CABINET MEMBER FOR ENVIRONMENT – 14 NOVEMBER 2019

WOODSTOCK A44 OXFORD ROAD – PROPOSED EXTENSION OF 30MPH SPEED LIMIT AND TOUCAN CROSSING

Report by Director for Community Operations (Interim)

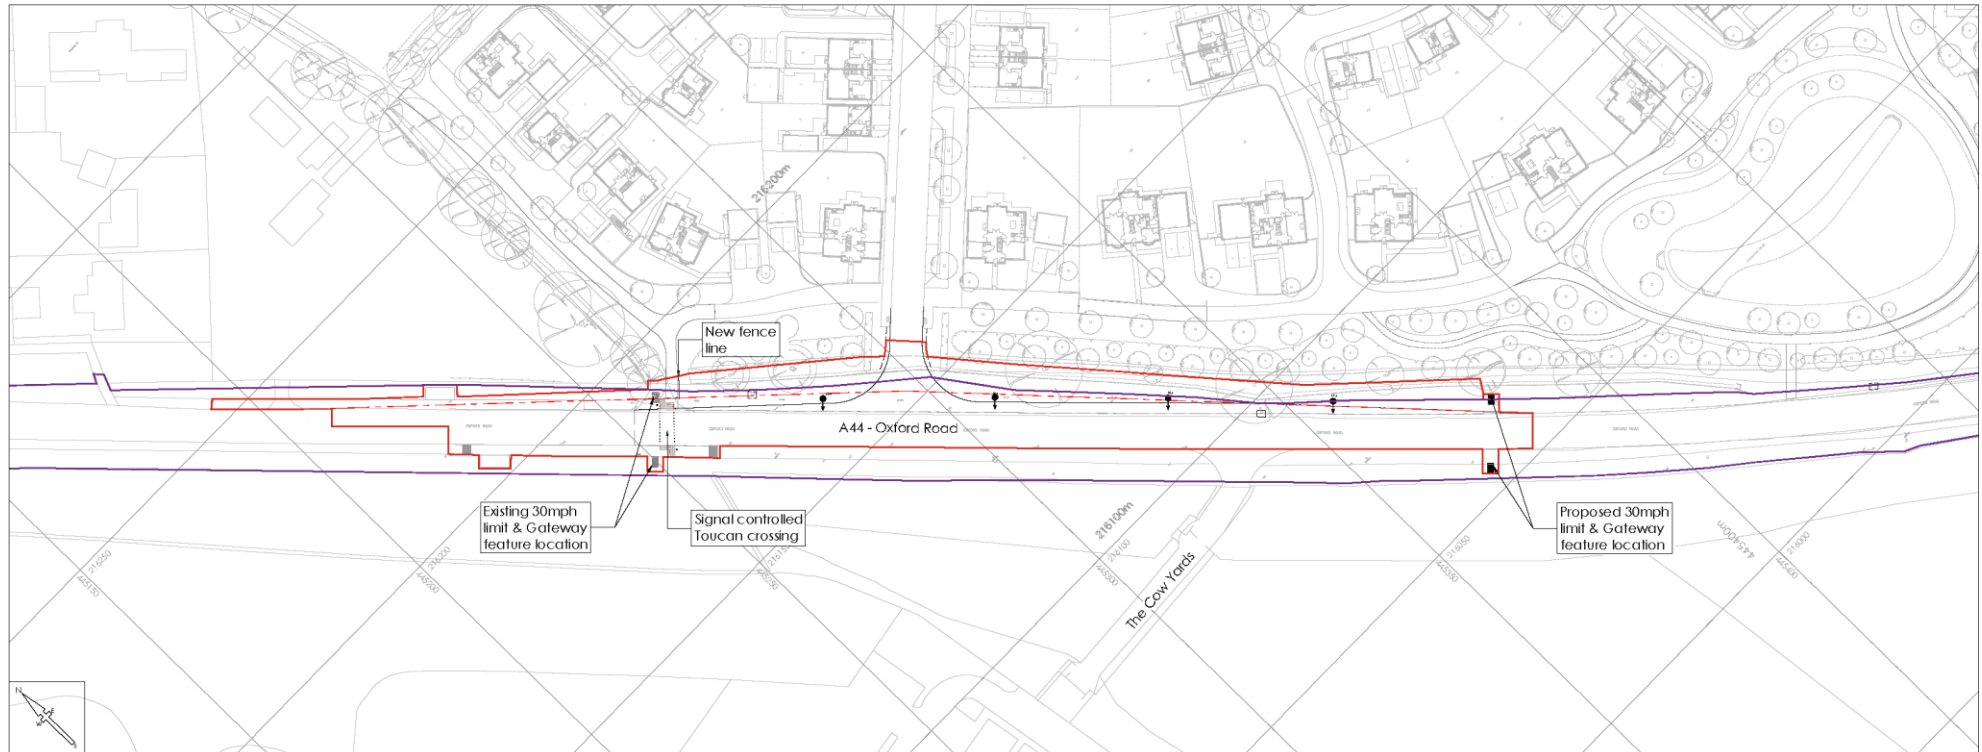
7. Thames Valley Police expressed an objection to the extension of the 30mph speed limit on the grounds that they did not consider it realistic taking account of the road environment even with the new junction and signalled crossing in place. In view of what they consider to be a high risk of abuse of the 30mph speed limit, the police have requested consideration of a 'buffer' 40mph speed limit in place of the current proposals. While acknowledging these concerns, the proposed length of extension of the existing 30mph speed limit is modest (approximately 150 metres) and is considered proportionate taking account of the new junction, signalled crossing and adjacent residential development which will change the road environment.

8. The objection from Begbroke Parish Council was primarily on the grounds that they consider the provision of a signalled pedestrian crossing at Begbroke, which has been a very long-standing request on the part of the parish council, to be a higher priority. Their response also noted concerns over crossing the A4095 at the A44/A4095 Bladon Roundabout (where there are currently only uncontrolled crossing points) and queries over the routes available to pedestrians, particularly for students attending the Marlborough School at Woodstock and also the provision of bus stops on the A44 Oxford Road adjacent to the development. The parish council also cited concerns over traffic delays caused by a signalled crossing.

11. The eleven responses from members of the public all expressed support for the proposals, although several requested consideration of further measures to improve the safety and amenity of pedestrians and cyclists, including

provision of a continuous footway on the east side of the A44 to link to the new residential development and also the widening of the existing footways including - on the west side - the shared use footway and cycle track.

9. In response to the above, while acknowledging the parish council's concerns over pedestrian safety at the A44 Begbroke Roundabout, the proposals are being funded and delivered by the residential development adjacent to the A44 Oxford Road at Woodstock to provide a safe route for pedestrians to the new bus stops on the A44 and also for pedestrians and cyclists continuing on the existing shared use footway/cycle track on the west side of the road. The proposals are considered proportionate taking account of the scale of the development and while the crossing will (as with any such crossing) introduce some delay to traffic, this is also considered proportionate to the benefits to the pedestrians (including the bus users walking to and from the crossing) and cyclists.

10. Wider plans for improvements are being developed for the A44 route which would have a particular emphasis on improving public transport and pedestrian and cycle provision, including at Begbroke.
